PROPOSED DEVELOPMENT at WOONTON FARM

PLOTS 4 & 5

D1808.7H

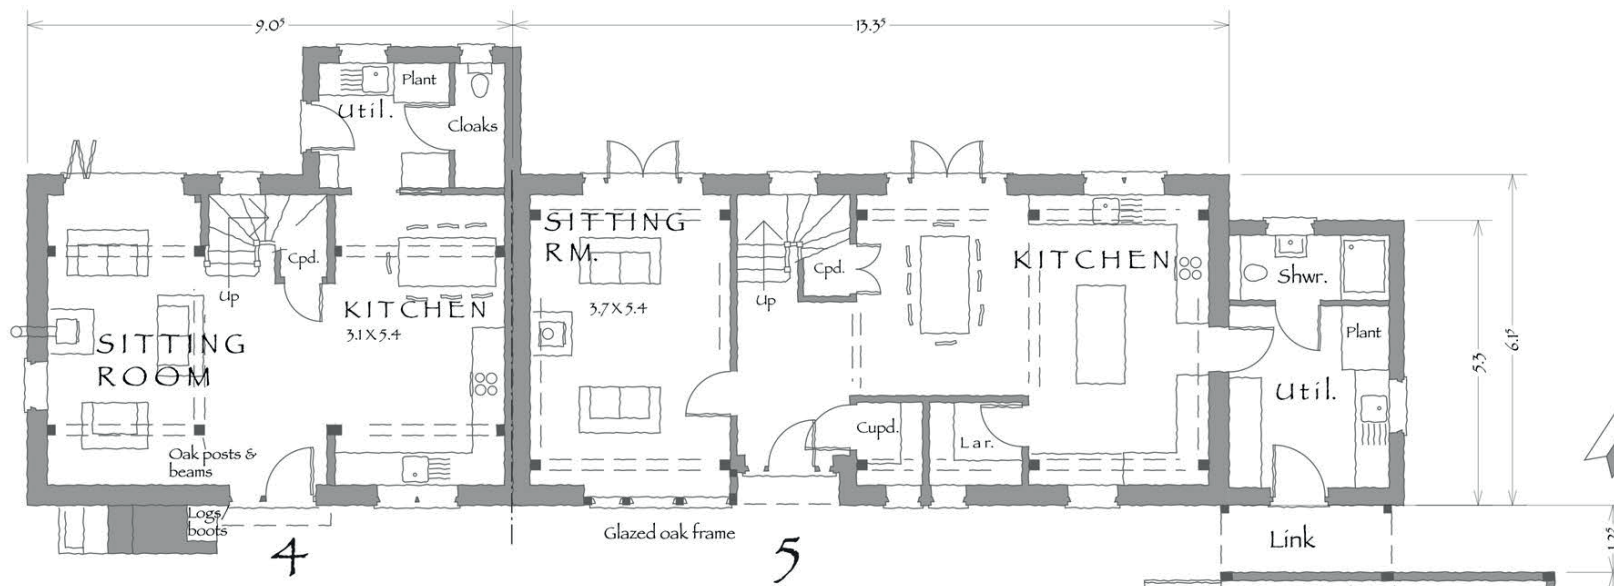
Revision C: 24.10.19 New scheme D:17.1.20 New scheme E:9.10.20 Drawing completed F:8.5.21 House 4 amended, car port incorporated G:9.3.22 Plot 4 flue moved to outside H:28.6.22 Stone gable removed from car port

D1808.8E

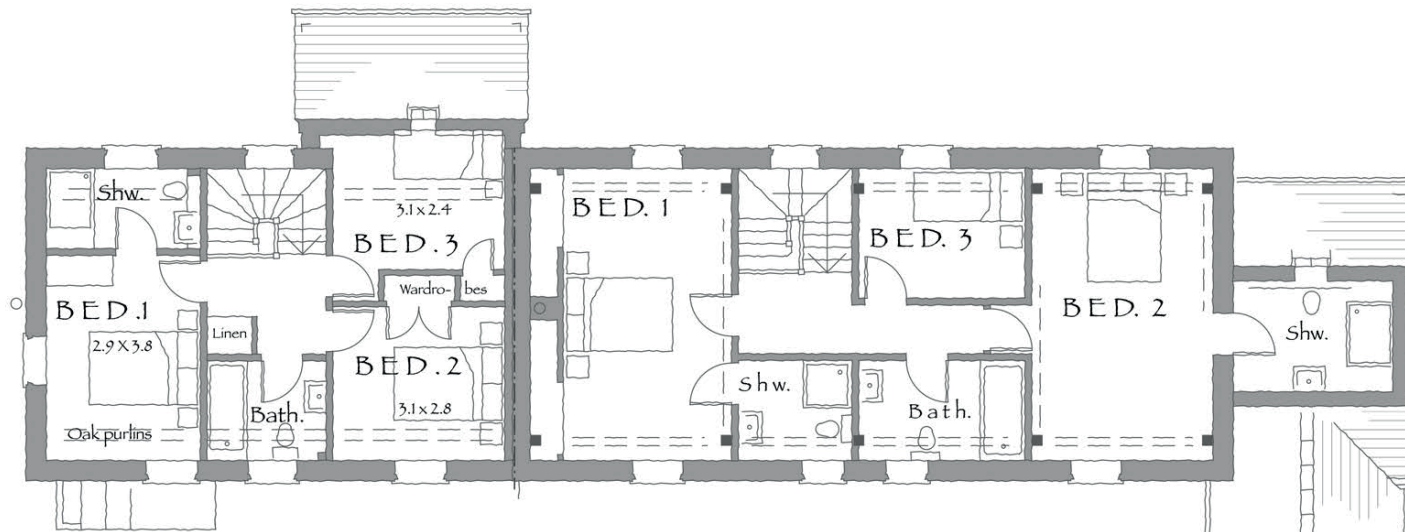
Revision C: 8.3.21 House 4 amended and car port incorporated D:9.3.22 Plot 4 flue moved to outside, rooflight added to garage, room layout amended to open up hall, subdivide bedroom & add shower rm. in plot4; reduce cupboards, remove wc & fireplace in plot 5 E:28.6.22 Stone gable removed rom car port

D1808.6H

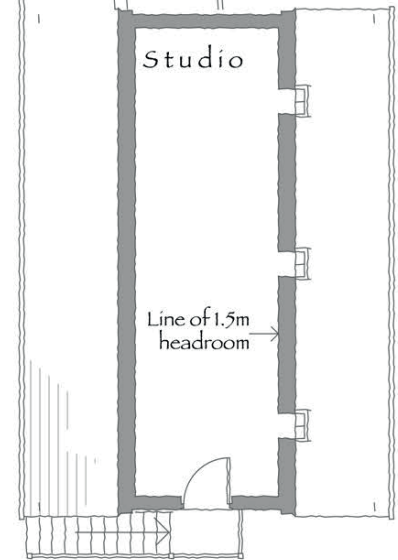
Revision F:9.3.22 Wall thicknesses amended to accommodate stone, plot 4 flue moved to outside, room layout amended to open up hall, first floor oak posts removed, subdivide bedroom & add shower rm. in plot 4, reduce cupboards, remove wc & fireplace in plot 5 G:28.6.22 Stone gable removed from car port
 ©All rights reserved
